Flight Procedures Cover Page	Task Action: FLIGHT CHECK	Task Type: IAP	Estimated Chart Date: 08/07/2025 APWS Task ID: 56C7549A63304739A20498D11691B139		APWS Project ID: 1680B6486CE84581AA1C1C3C417A9B26		
Procedure: RNAV (GPS) RWY 12 ORIG		Enroute: NO	Specialist: Keefer, John		Agreement Number:		
Airport ID: S64			Airport City: STANFORD		State: MT		
Facility ID:	Facility Type:	Flight Inspection Rema	rk Type:

FIPC BASIC FORM																		
PROCEDURE:						AIRPORT NAME: AIRPO				IRPO	RT ID: SPECIAL C		CONTROL NO:					
RNAV (GPS) RWY 12 ORIG						STANFORD/BIGGERSSTAFF FLD KS64				KS64	SG-02-148-2			25				
FAC ID: KS6412 CITY: STANFORD						ST: MT					ORIG CHART DATE: 08/07/2025					25		
DFL TYPE:	THIRD P	PARTY:	EST. TIMI	T. TIME ON SITE: REIMB. NUMBER: PTS TASK ID:							·							
PROC/G		YES	0.5 56C7549A63304739A20498D11691B139							.39								
PREFLIGHT NOTES																		
REVIEWER: DATE:																		
COMMENTS:												CHECK (ONE:					
												FLT (FLT CK REQ NFCR			RE.	☐ REJECT	
																YES	NO	
												CPV COM	IPLE	TE?		X		
					P	ROCI	EDURE I	RESU	ULTS	5								
INSPECTION DA	ΓΙΟΝ DATE: CREW #: N #:				II	INSTRUMENT PROCEDURE STATUS:						ARINC CODING

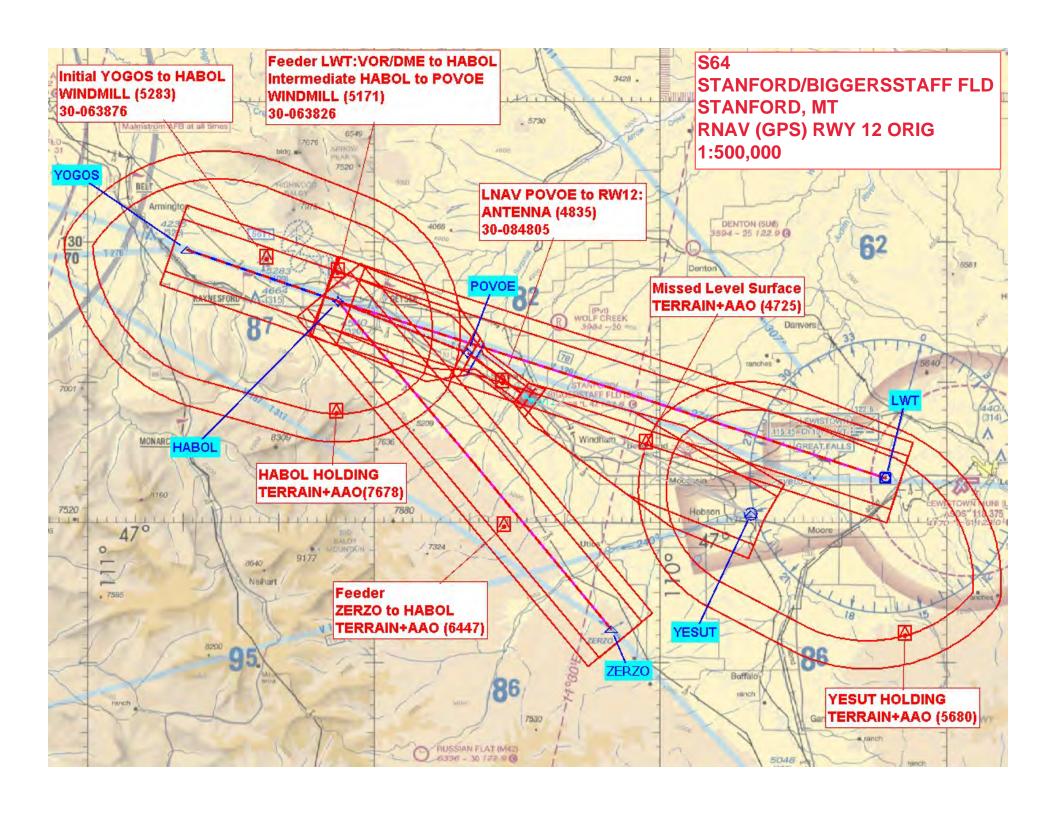
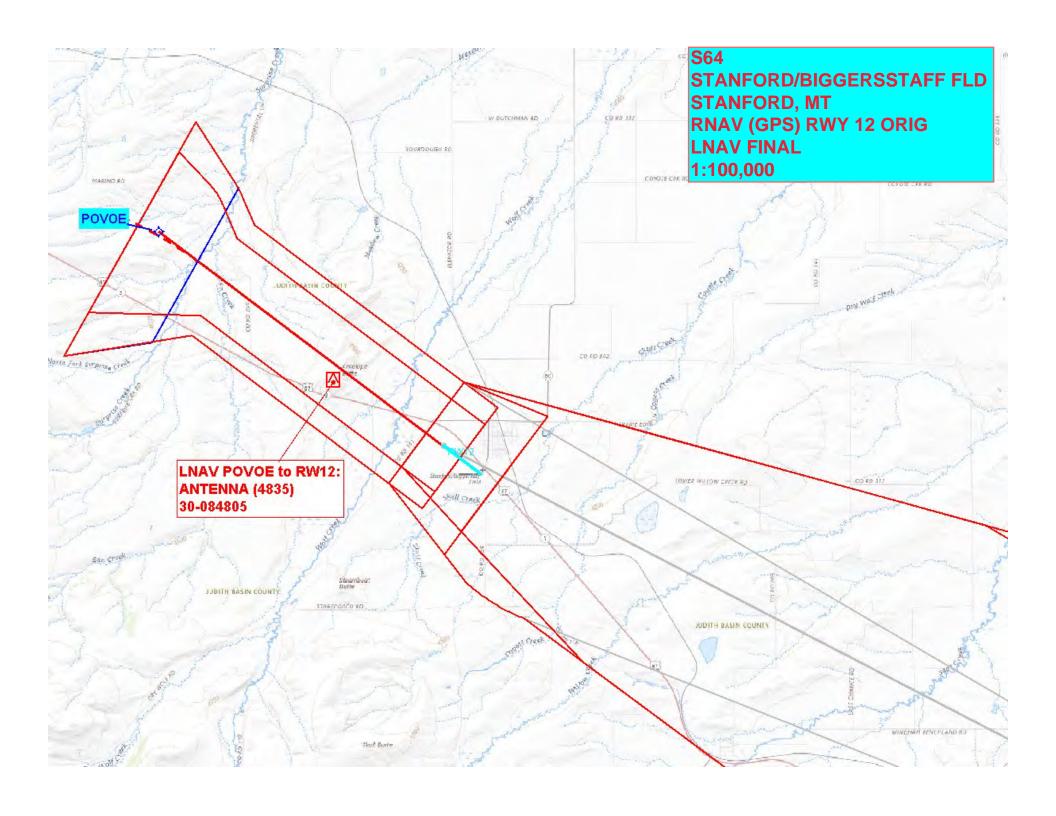
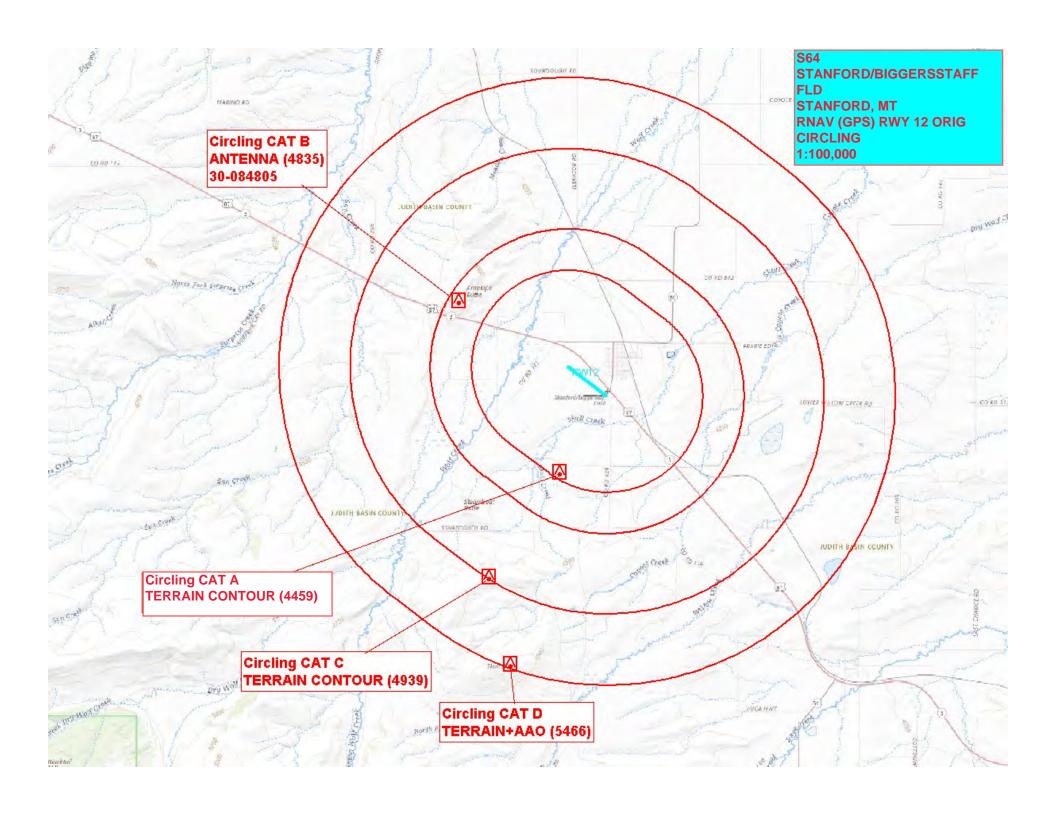
4/1/2025: THIS IS AN UPDATED COPY OF THE FORMS DEVELOPED ON 12/17/2024. RAISE CAT C CIRCLING MDA TO 5600 PER FLIGHT INSPECTION. NEW MDA/VIS/HAA 5600/3/1272.

06/06/2025: THIS IS A CORRECTED COPY OF THE FORM APPROVED ON 04/01/2025. CORRECTED TYPO CHANGED CIRCLING CAT C HAA FROM 1722 TO 1272 .

wendi s gima @ 04/	/01/2025 1	10:18			(GIMA, WENDI SUEMI							YES X NO					
FLIGHT INSPECTOR REMARKS: STANDFORD/BIGGERSSTAFF FLD (S64), STANDFORD, MONTANA, RNAV (GPS) RWY 12 Commission, SAT w/Changes*. CAT-C circling unsat for obstacle clearance. Periodic requirements met. *Change required: Raise CAT C minimums to 5600' to provide adequate obstacle clearance.																		
	IN-FLIGHT OBSTACLE REPORT																	
OBSTRUCTION I	D #: CC	COORDINATES OR LOCATION: GNSS ALTITUDE (MSL): BAROMETRIC ALTITUDE (MSL): HEIGHT ABOVE GROUND LEVE							EVEL:
